2.0 SAFETY LIMITS AND LIMITING SAFETY SYSTEM SETTINGS

DAVIS-BESSE, UNIT 1

Amendment No. 17, 18, 22
8, 17, 80

Figure 3.1-5b APSR Position Limits After
325 ± 10 EFPD, Three or Four RC
Pumps, APSRs Withdrawn --
Davis-Besse 1, Cycle 6

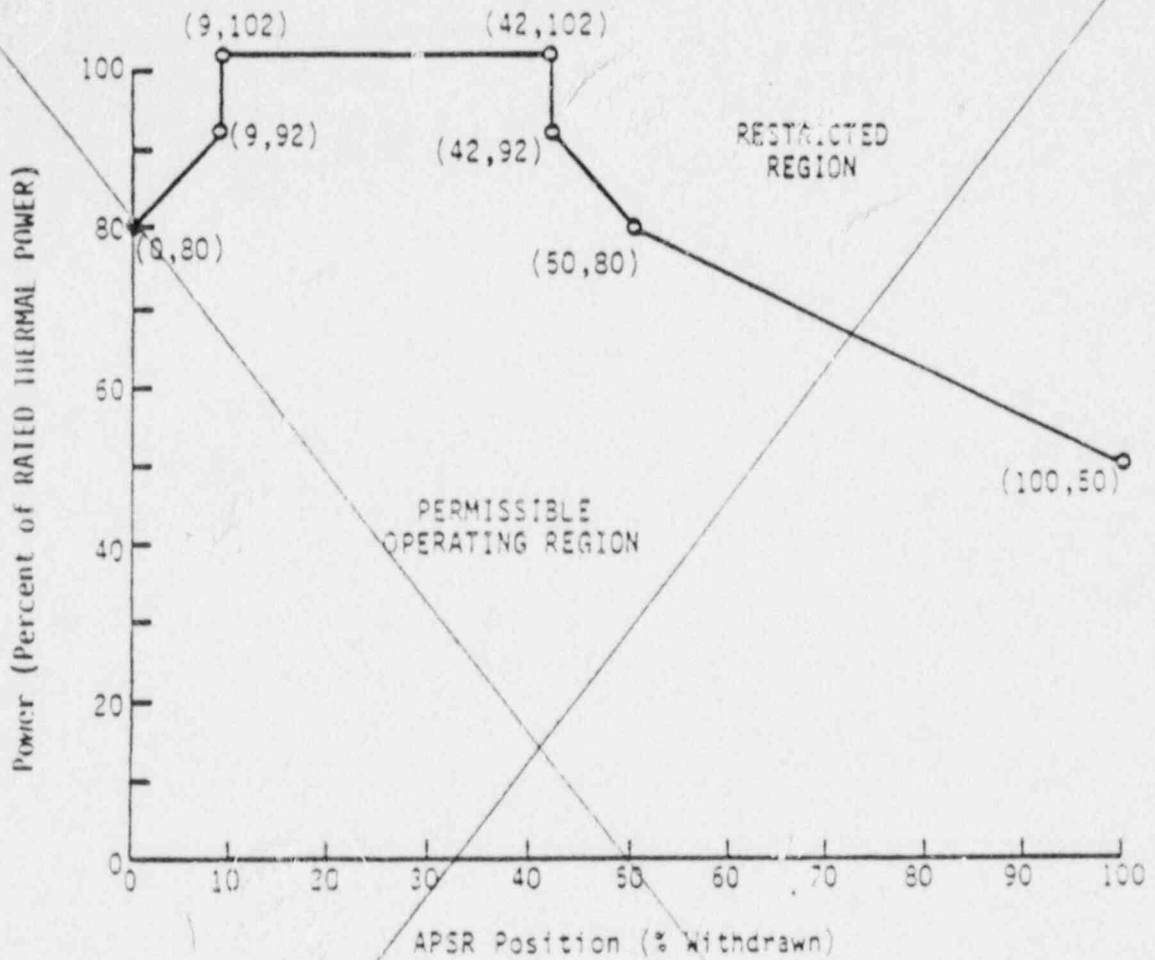
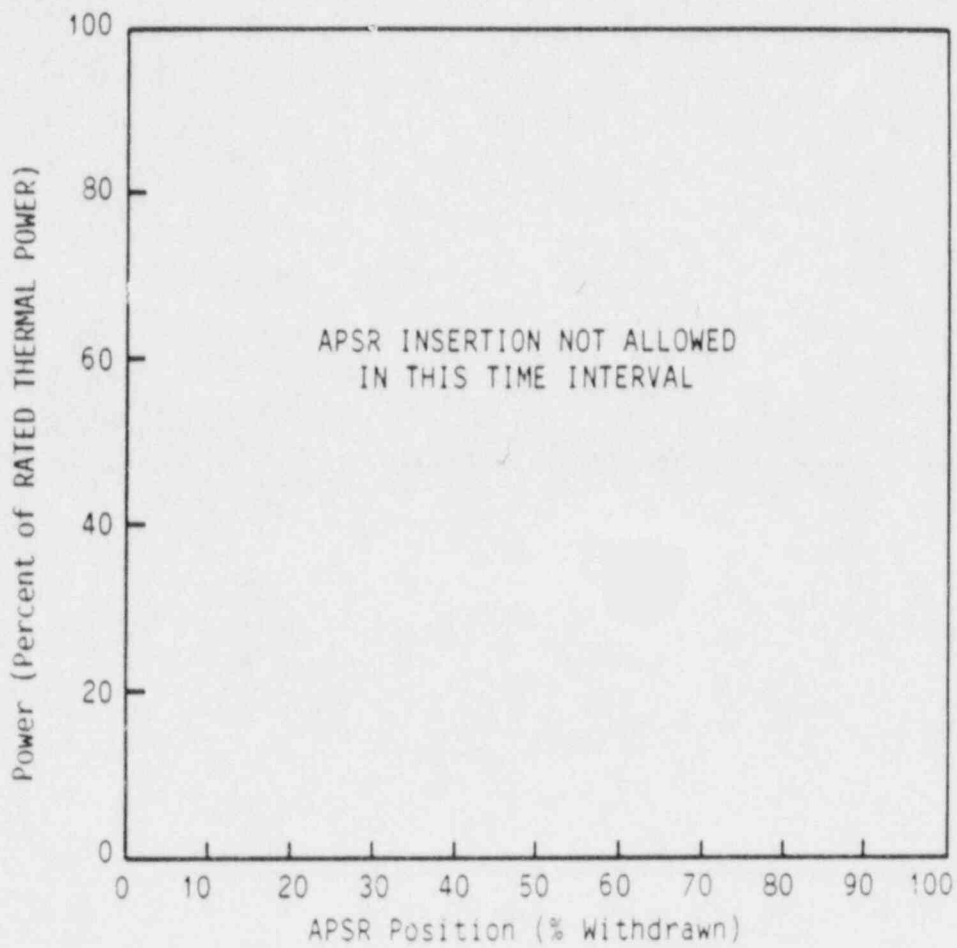
Superseded with new Figure 3.1-5b

Figure 3.1-5c APSR Position Limits, 0 to 325 ± 10 EFPD,
Three RC Pumps -- Davis-Besse 1, Cycle 6

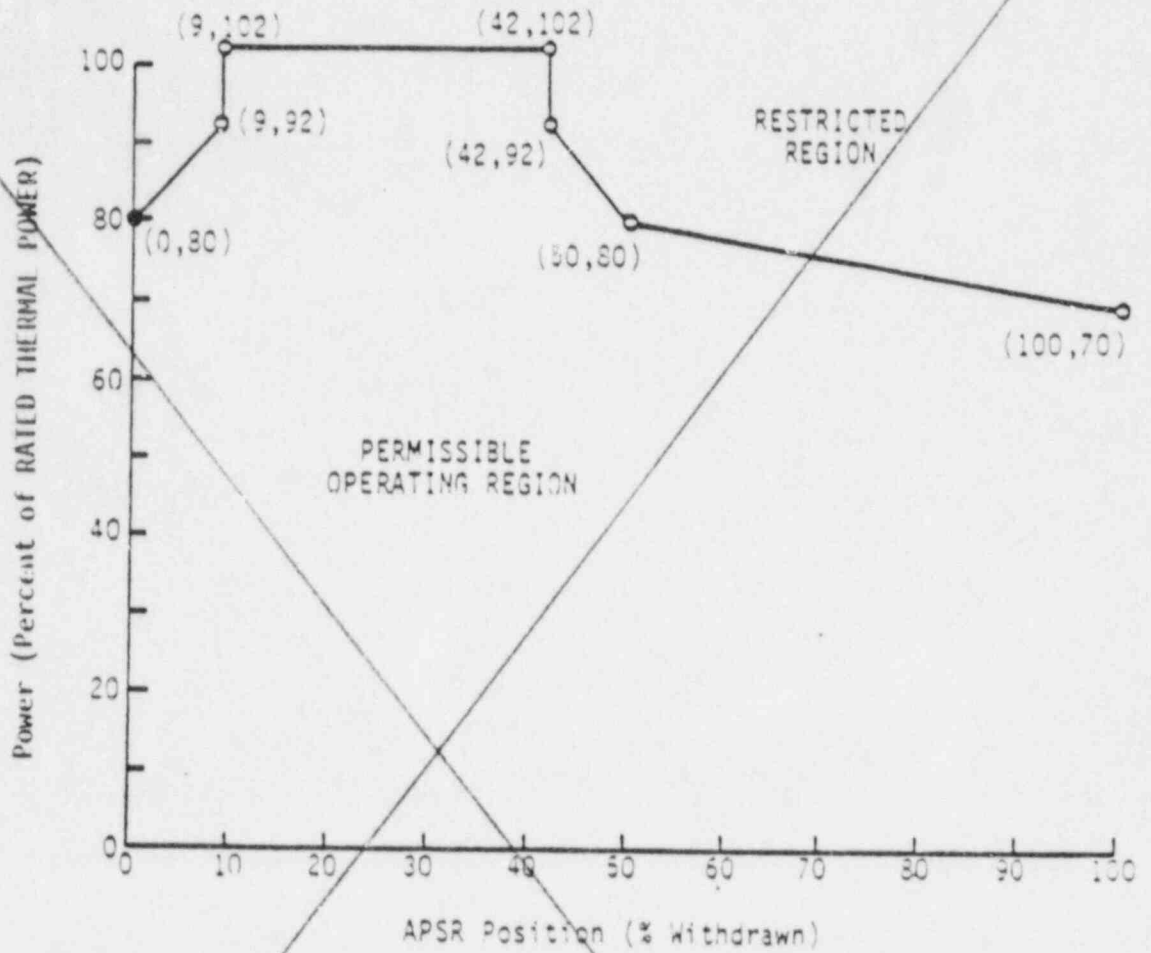
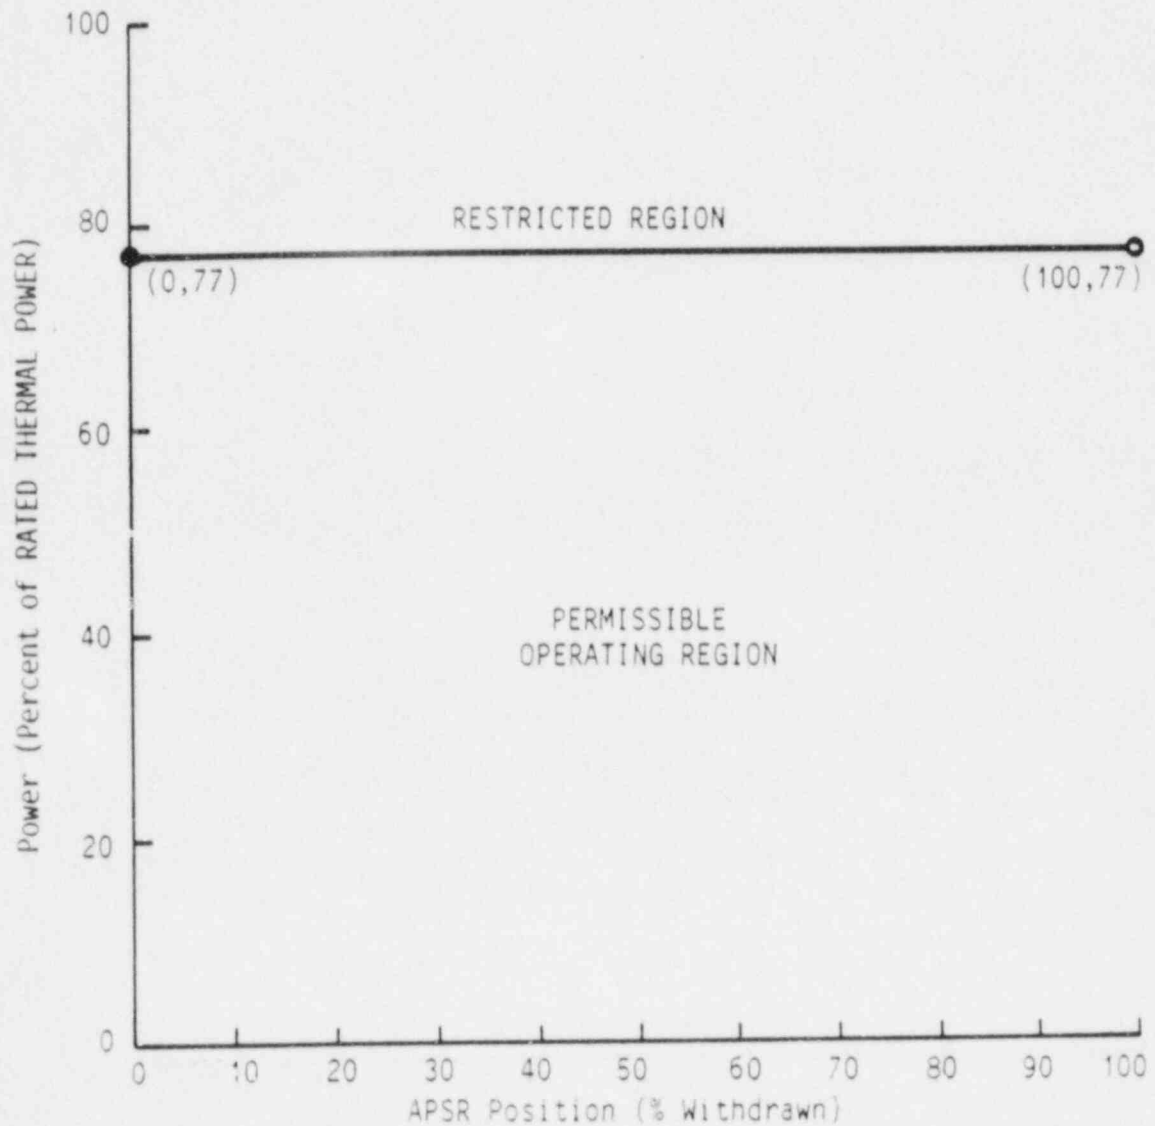
Superseded with new Figure 3.1-5c

Figure 3.2-1 AXIAL POWER IMBALANCE Limits,
 Four RC Pumps -- Davis-Besse 1,
 Cycle 6

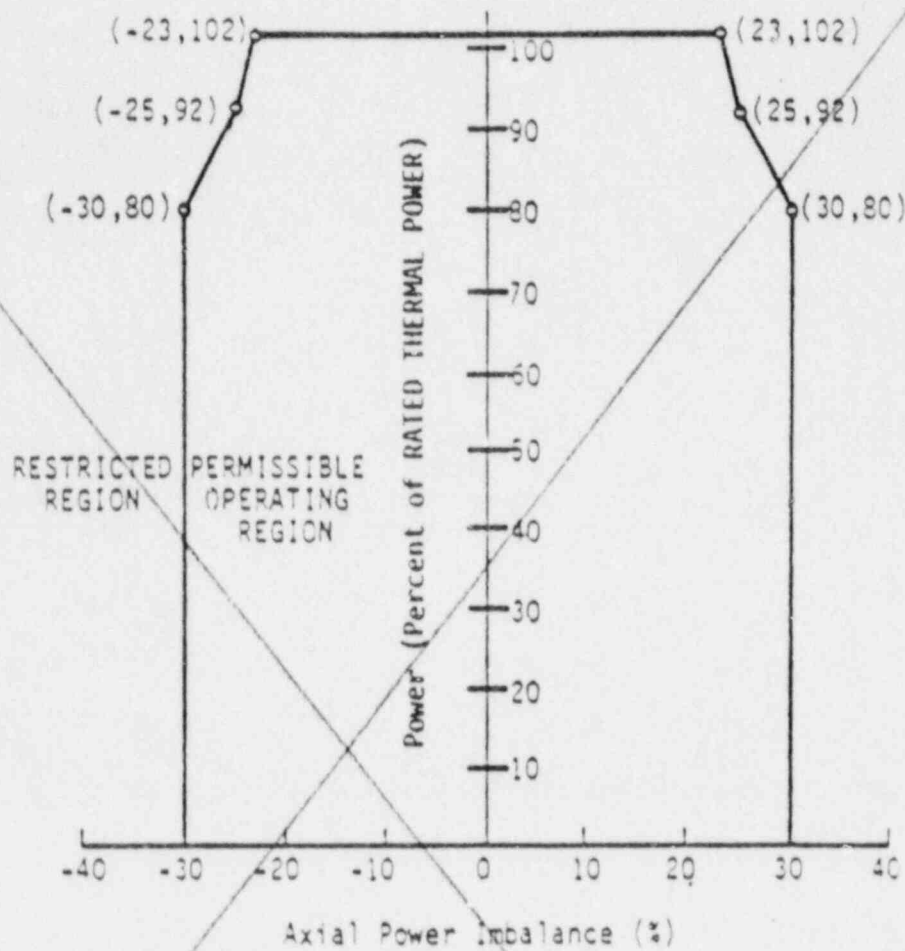
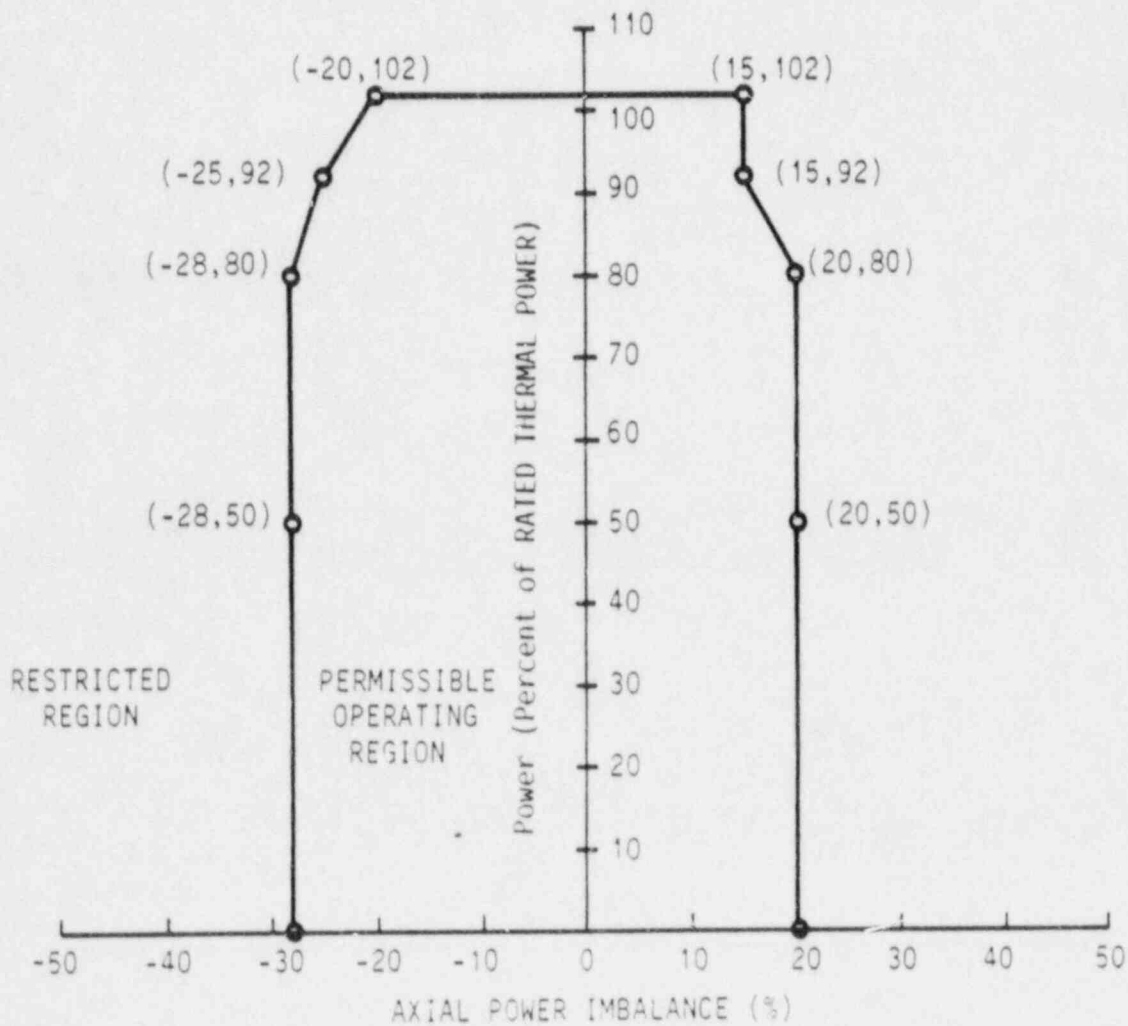
3.2.1 AXIAL POWER IMBALANCE shall be maintained within the limits shown on Figures ~~3.2-1a, 1b, 1c, and 1d and 3.2-2a, 2b, 2c and 2d~~ 3.2-1 and 3.2-2.

Superseded with new Figure 3.2-1

Figure 3.2-2 AXIAL POWER IMBALANCE Limits,
 Three RC Pumps -- Davis-Besse 1,
 Cycle 6

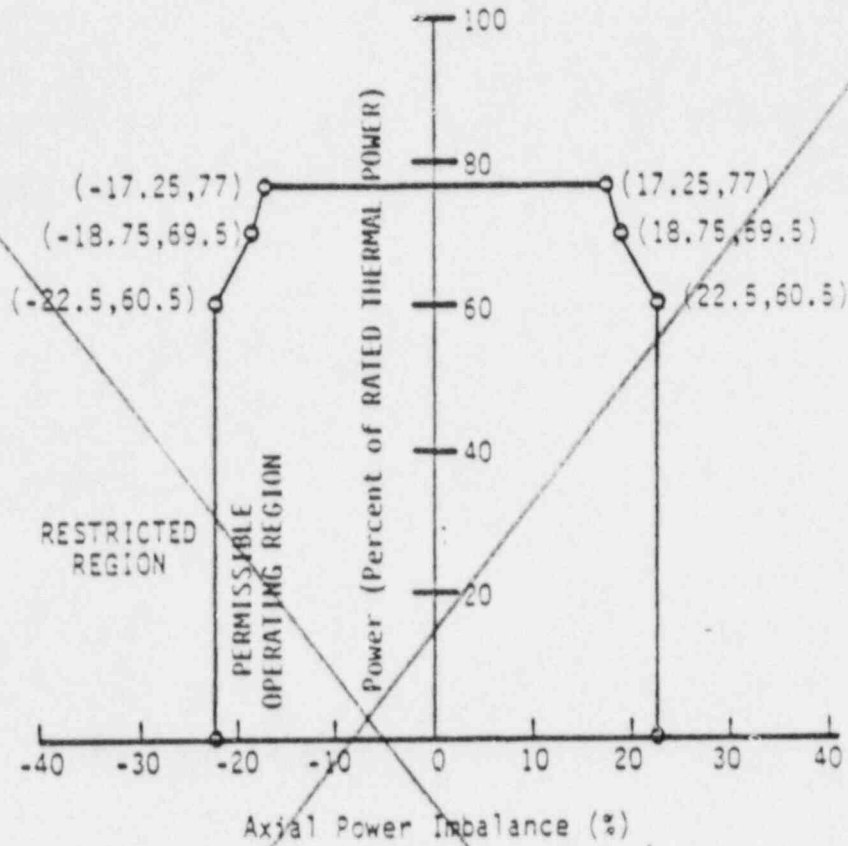
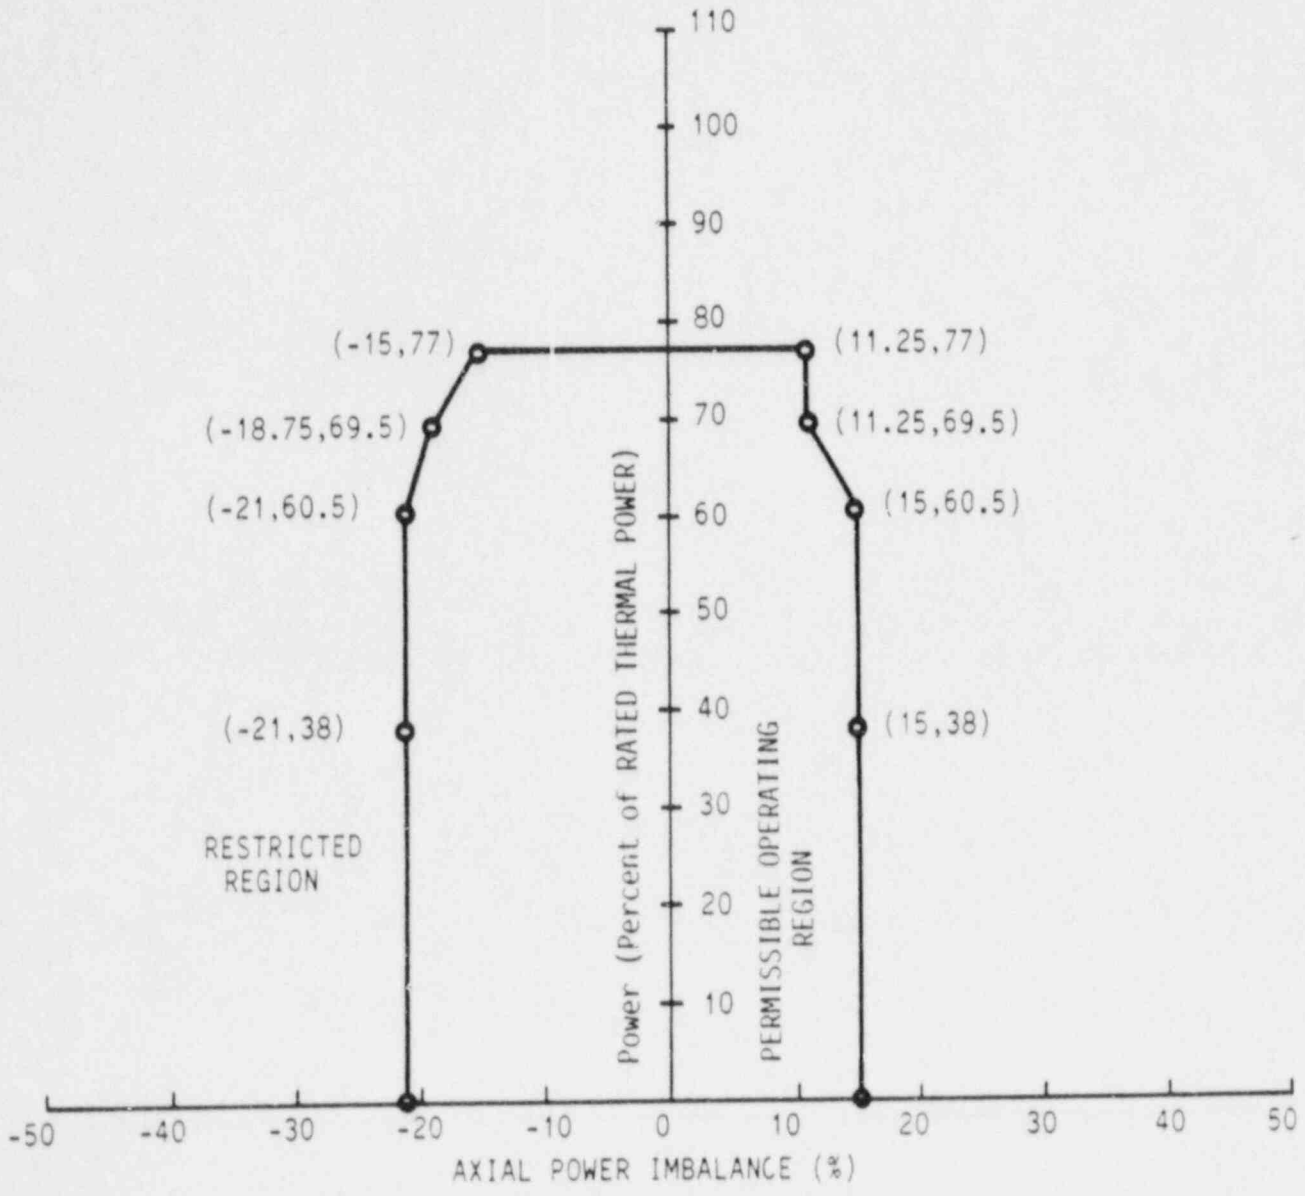
Superseded with new Figure 3.2-2
